SITE DEVELOPMENT PLAN

BELIEVERS CENTER OF ALBUQUERQUE
NEW CHURCH FACILITY

sheet title:
SITE PLAN
ENLARGED PLANS

C3.1

SITE PLAN

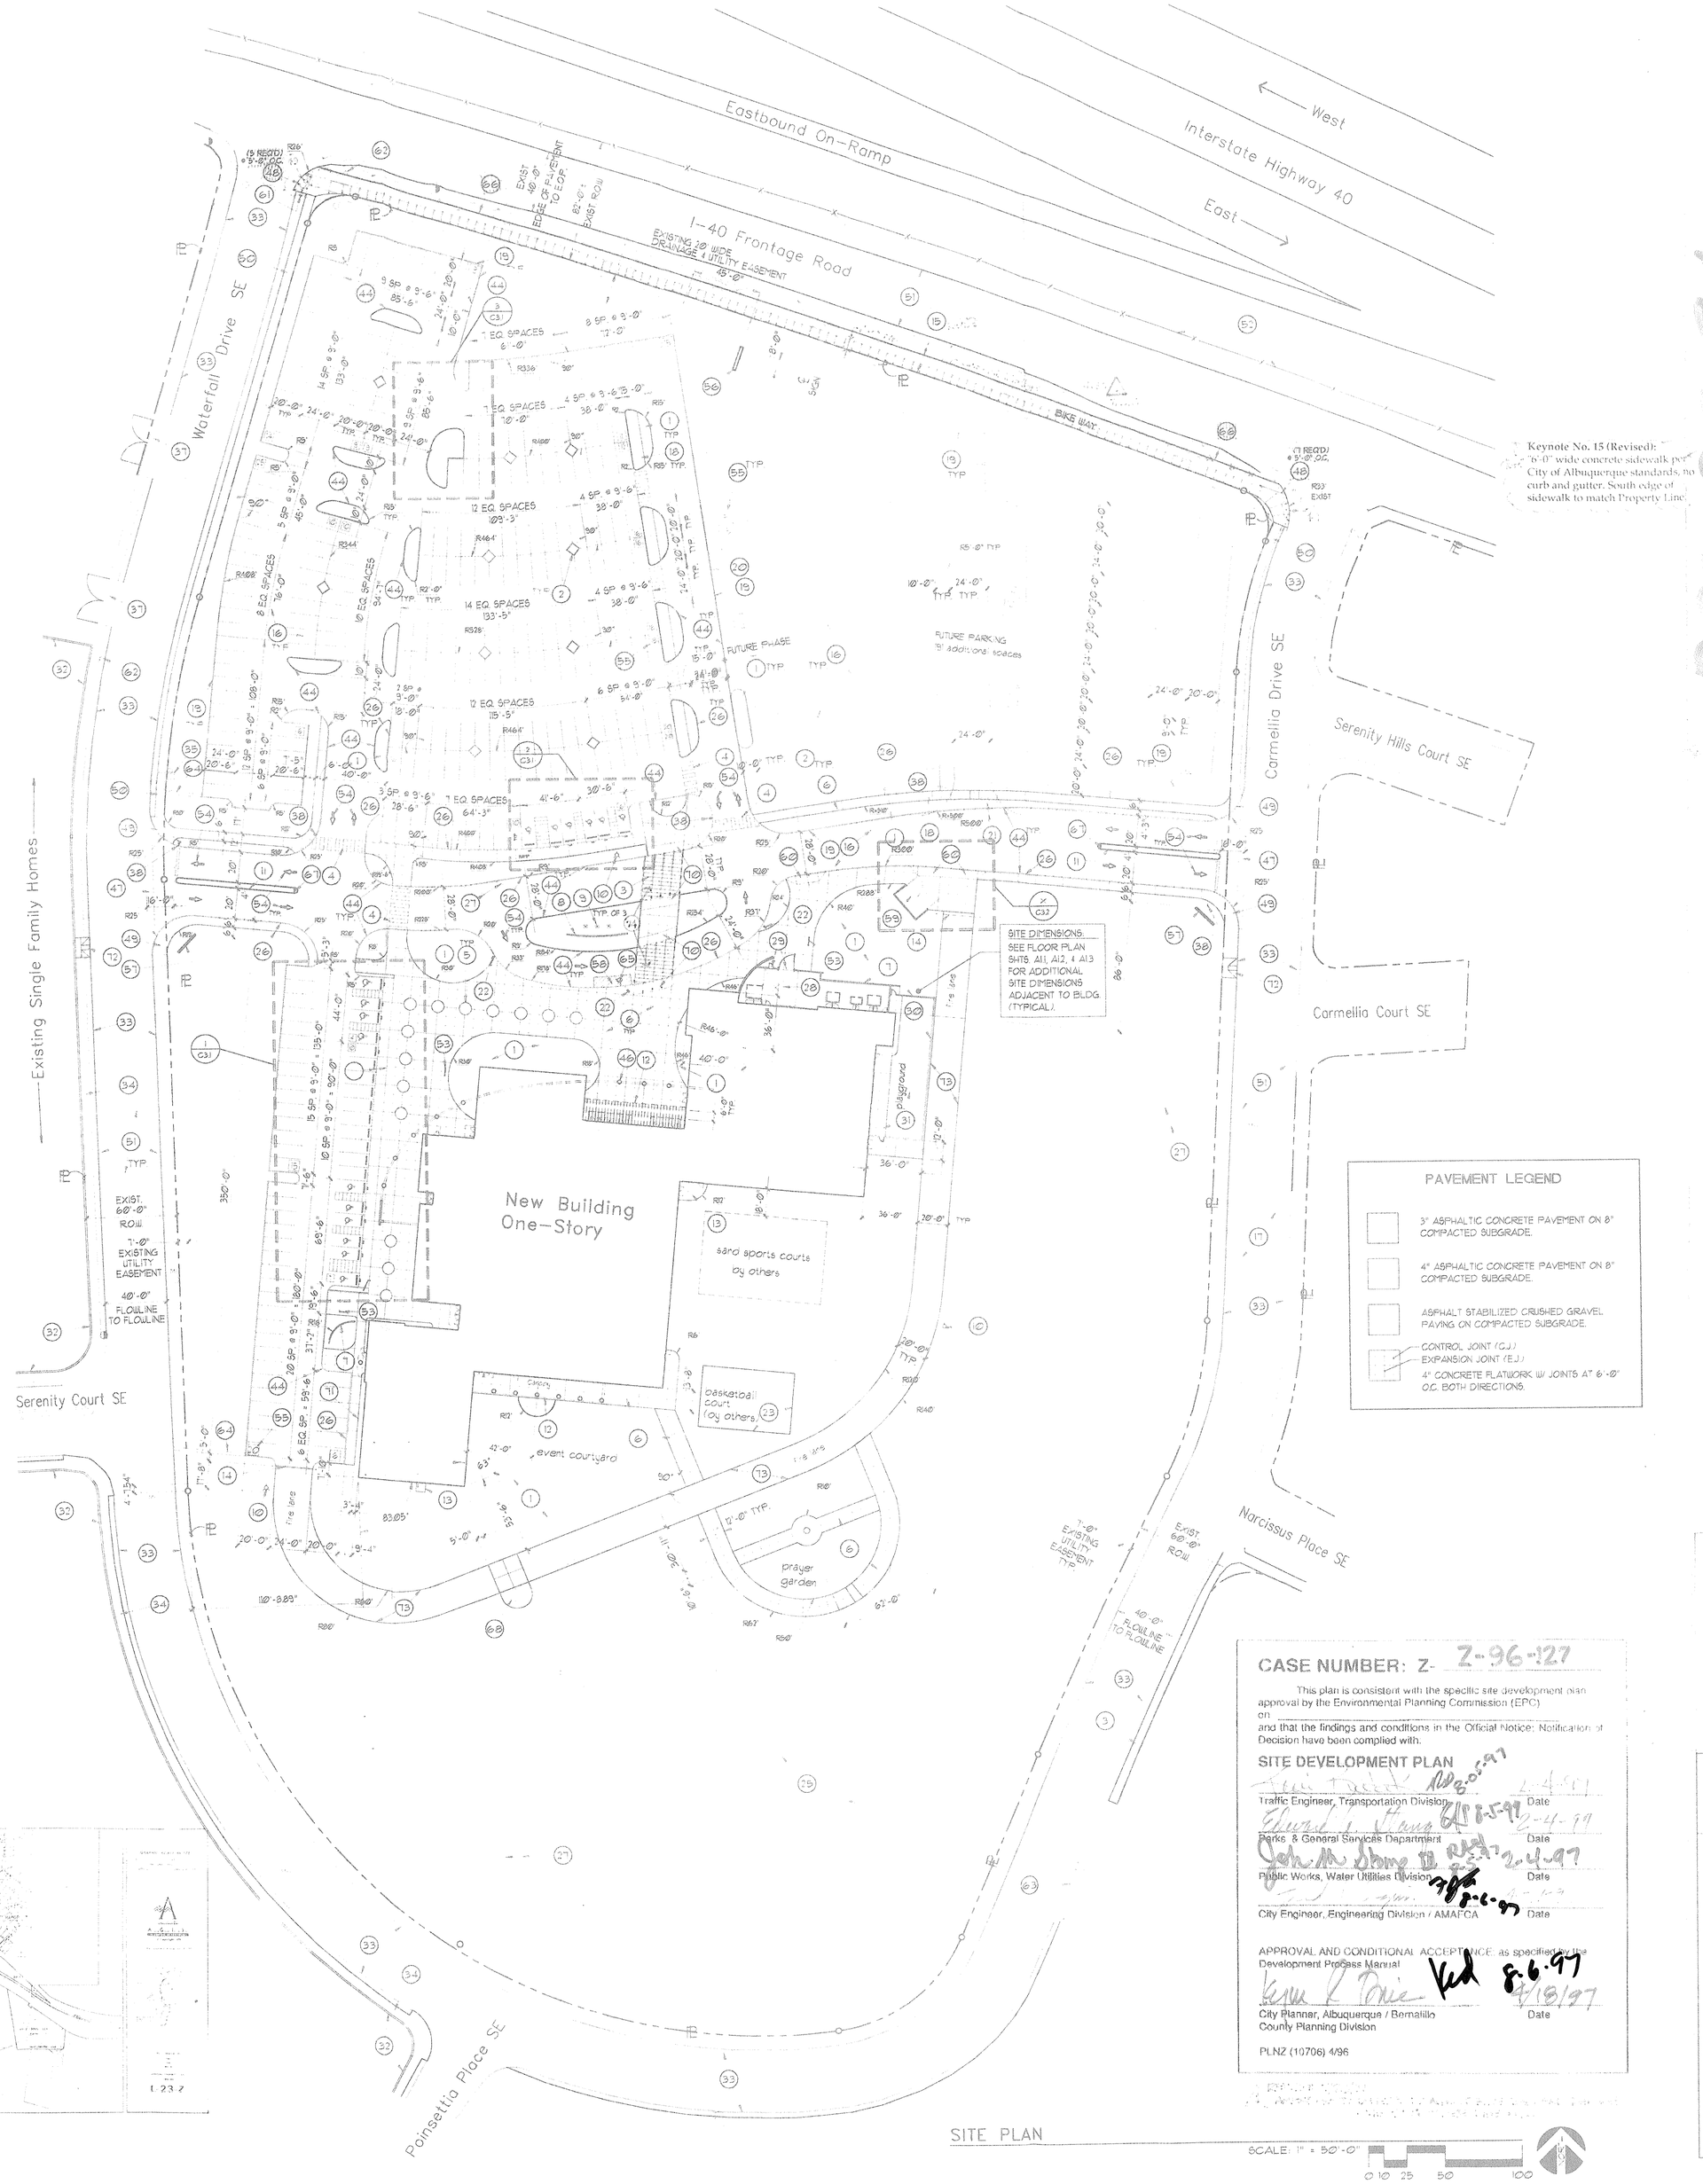
Keynote No. 15 (Revised): "6'-0" wide concrete sidewalk per City of Albuquerque standards, no curb and gutter. South edge of sidewalk to match Property Line."
